PROJECT: Farm and Jensen Elementary Schos I

CITY OF LAS VEGAS INTER-OFFICE MEMORANDUM		DATE: April 13, 2017
TO: Land Development Services Department of Building & Safety		FROM: Albert Sung, P.E. Flood Control Project Engineer Department of Public Works
SUBJECT: Drainage Study for: Farm and Jensen Elementary School		COPIES TO: Collins Engineers, Inc.
Cross Streets:	NWC of Farm Road & Jensen Street	SH Architecture
File Number:	F:\Depot\DSMemos\DS4856B.doc	Bart Anderson, P.E., DevCo
Parcel Number:	125-18-201-015	
Zoning Action:	SDR-xxxxx	
FEMA Flood Zone	YES NO X	
Proposed Storm Drain	YES NO X

Addendum 1 to the TDS for Farm and Jensen Elementary School

April 2017

FIG. 9

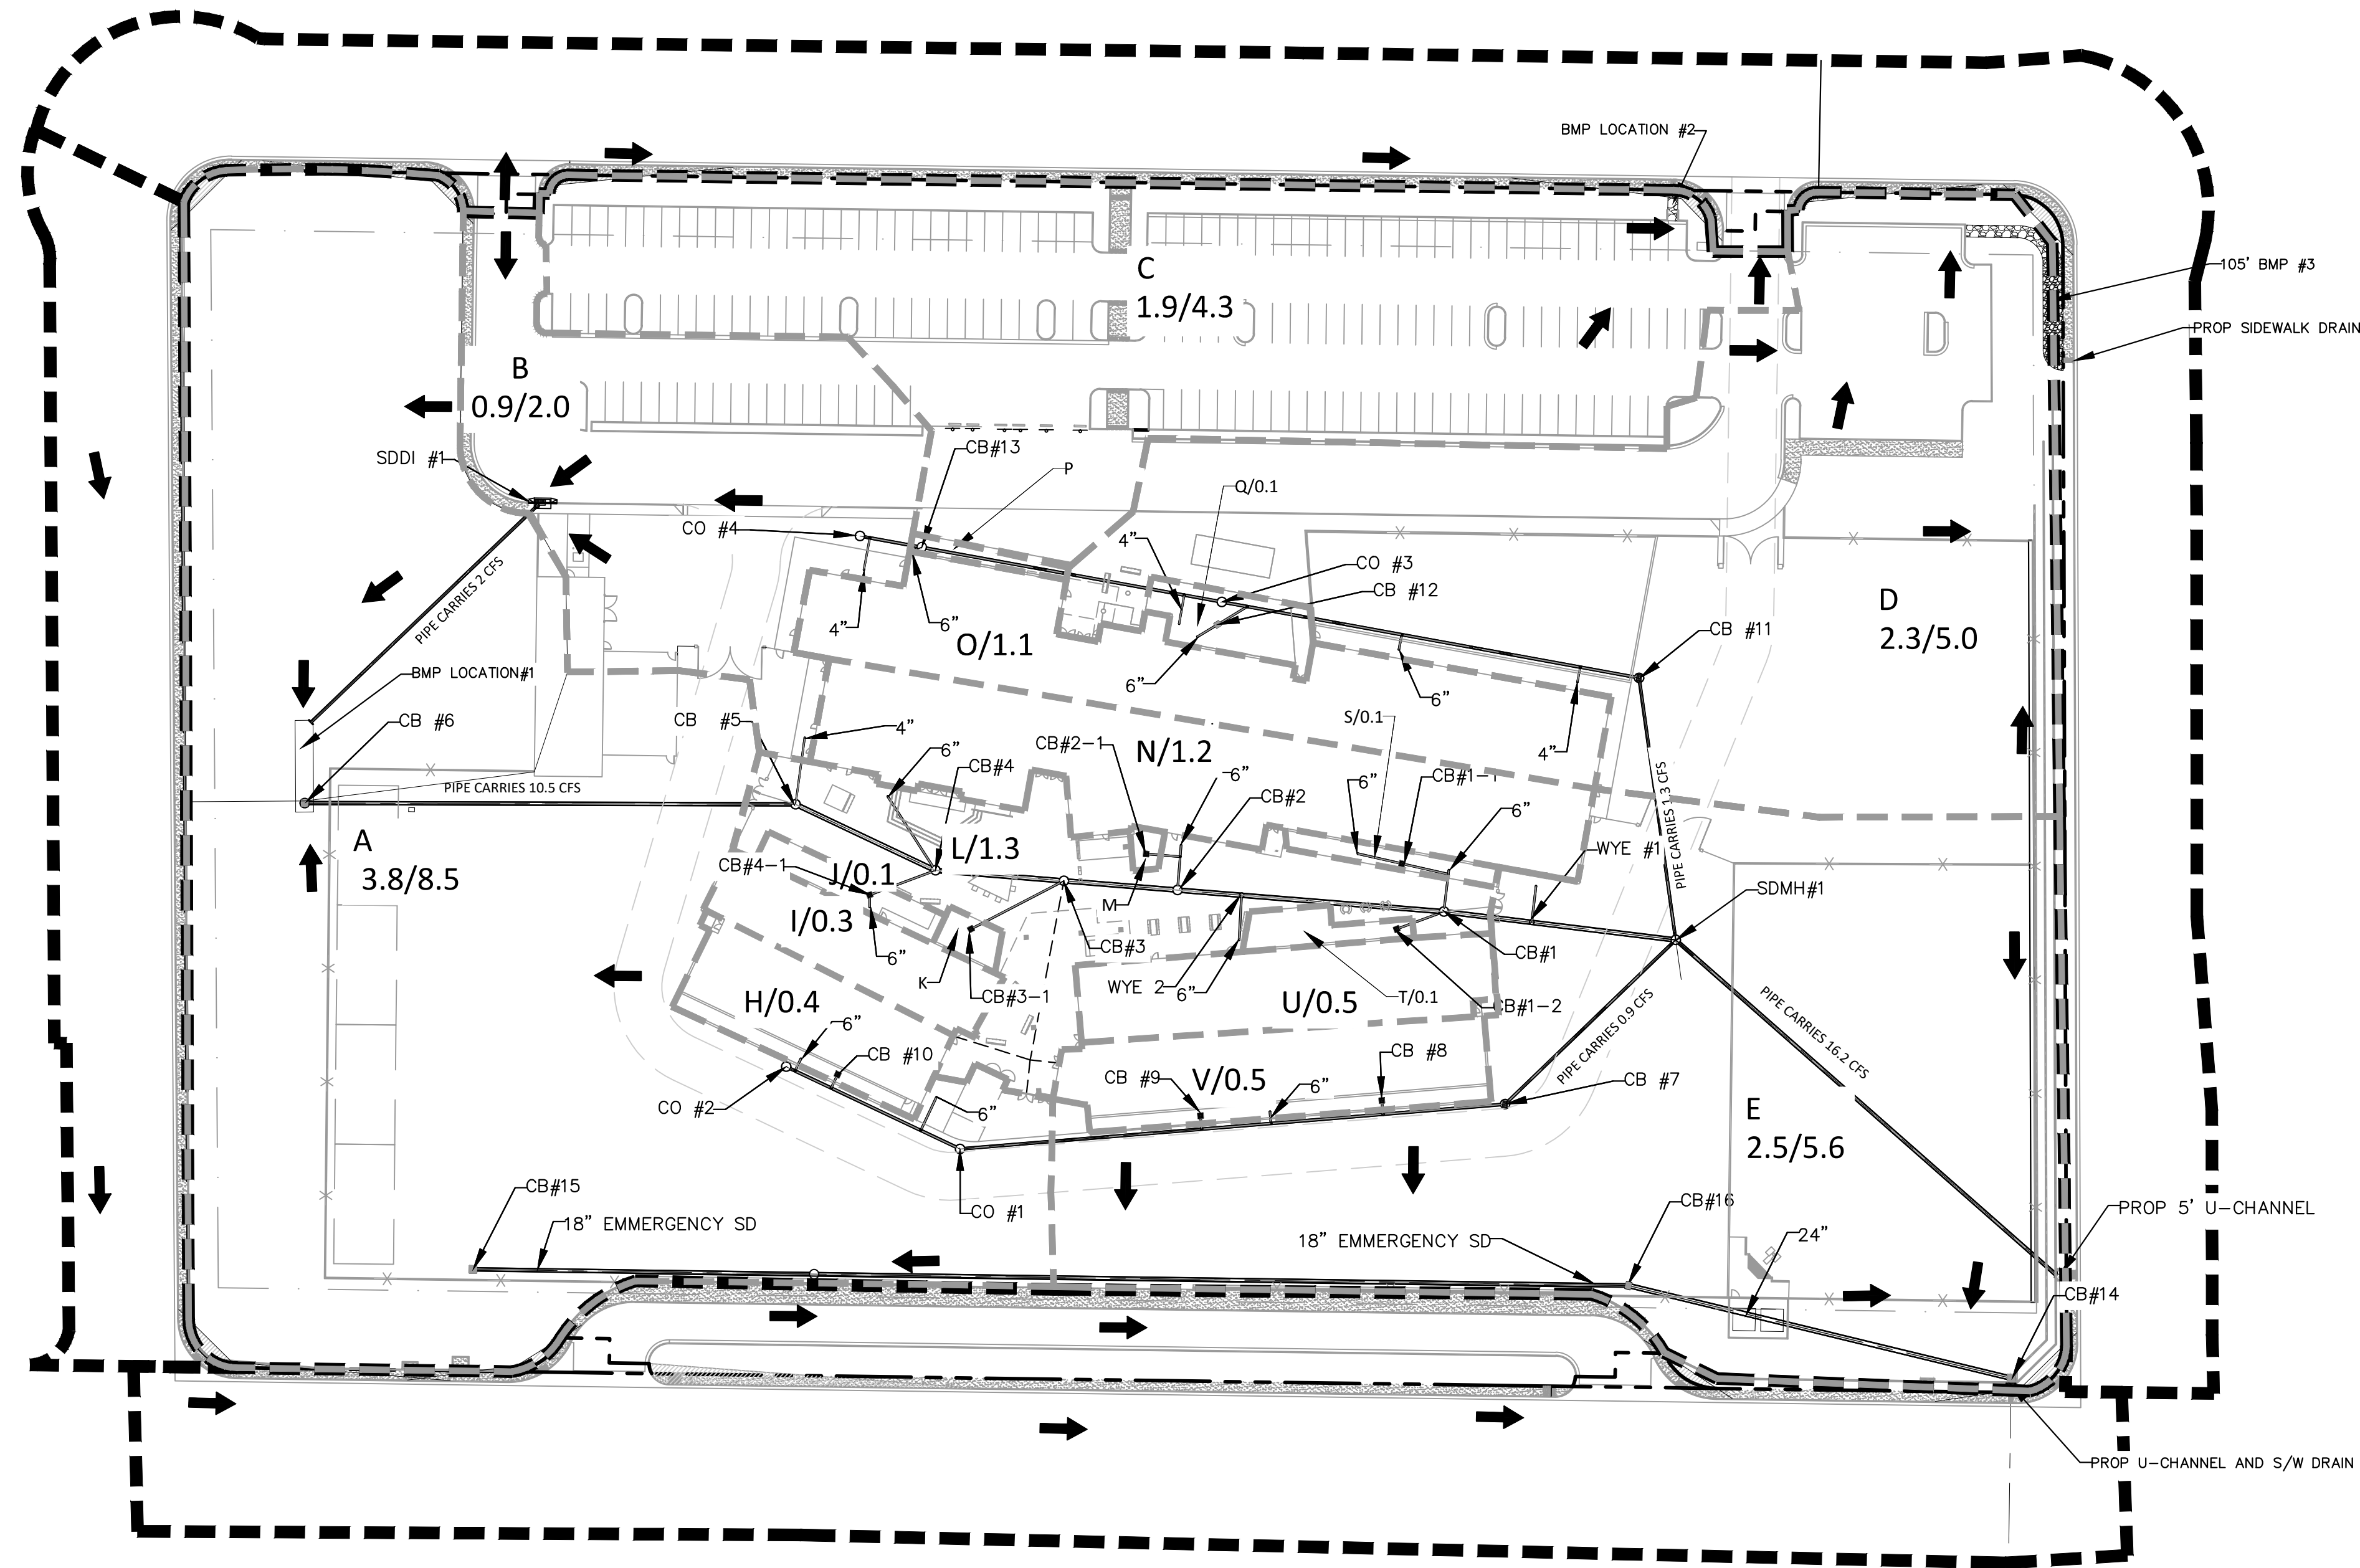
entering the community. Review and revise the existing and proposed drainage condition maps accordingly in the next submittal.

In the Proposed Condition which is shown in Figure 10, at the southeast corner of the site (at CP-2 or FlowMaster Section FM-5) generated a total of 287.5/560.6 cfs, and at CP-1(at FM-6) a total of 11.3/25.2 cfs. Basin Maps have been revised to show the combination points and included in Appendix B.

A
C8.01 CROSS SECTION
NTS

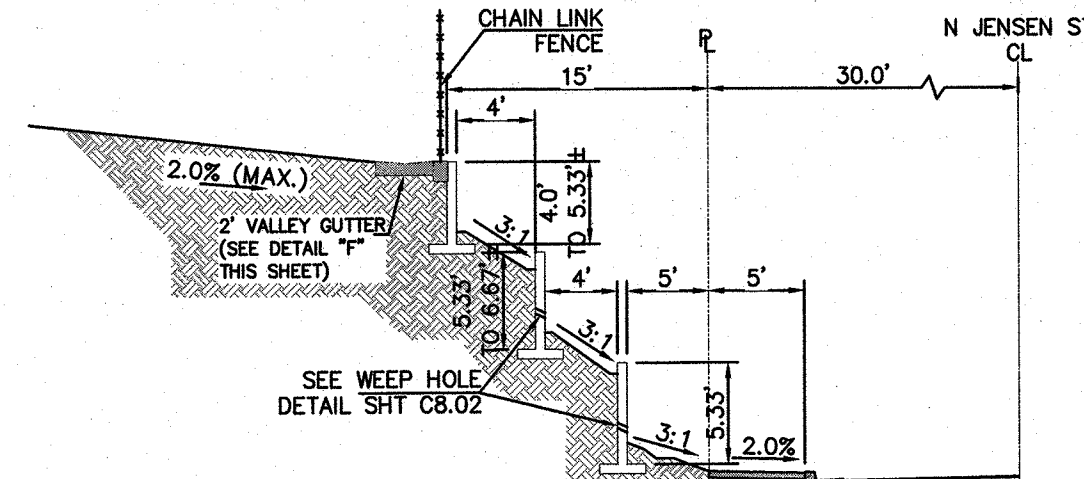
Sheet C8.01: Detail Section A: Clearly label the 18"-stem wall to be solid grouted 8"-CMU or equivalent.

The detail has labeled as 18" concrete stem wall above the TC elevation.
